Access Compliance Report

Public Rights-of-Way

(Curb Ramps)

Intersection ID: 10996	Main Street: E_24TH_ST	Cross Street: N_DAVIDSON_ST	Location: N
ADA ID: B2D543AA807C	Ramp Type: Perp	Initial Pass/Fail: Fail	Overall Compliance: No
Severity Score: 35			
Codes/Mitigation Info/Possible Solution		Field Measurements/Component Compliance

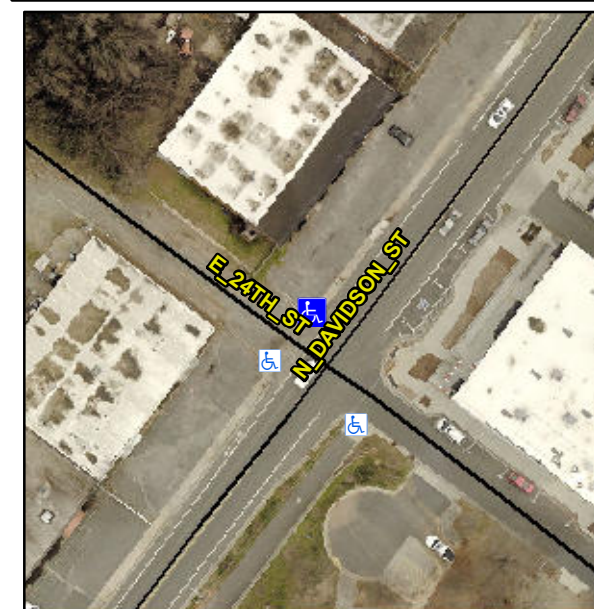
Not Found, R304.5.1, R304.2.2

Compliance	Description	Data	Compliance	Description	Data
N/A	Ramp Length (in)	41.0	No	Ramp Slope (%)	12.2
No	Ramp Width (in)	41.5	Yes	Ramp XSlope (%)	3.3
N/A	Flare Type LT	N/A	N/A	Flare Type RT	N/A
N/A	Flare Slope LT (%)	N/A	N/A	Flare Slope RT (%)	N/A
N/A	Flare Traversable LT?	N/A	N/A	Flare Traversable RT?	N/A
N/A	Landing Length (in)	N/A	N/A	DWS Provided?	N/A
N/A	Landing Width (in)	N/A	N/A	DWS Contrast?	N/A
N/A	Landing Slope (%)	N/A	N/A	DWS Length (in)	N/A
N/A	Landing X Slope (%)	N/A	N/A	DWS Full Width?	N/A
N/A	Landing Curb? (Y/N)	N/A	N/A	DWS Offset (in)	N/A
N/A	Shared Landing?	N/A			
N/A	Gutter Ponding?	N/A	N/A	Gutter Slope (%)	N/A
N/A	Gutter Lip Ht (in)	N/A	N/A	Gutter X Slope (%)	N/A
N/A	Painted X Walk1?	No	N/A	Painted X Walk2?	N/A
	X Walk 1 Direction	To SW		X Walk 2 Direction	N/A
N/A	X Walk 1 Width (in)	N/A	N/A	X Walk 2 Width (in)	N/A
	X Walk 1 Slope (%)	0.4		X Walk 2 Slope (%)	N/A
	X Walk 1 X Slope (%)	7.8		X Walk 2 X Slope (%)	N/A

Remove & Replace Entire Ramp.
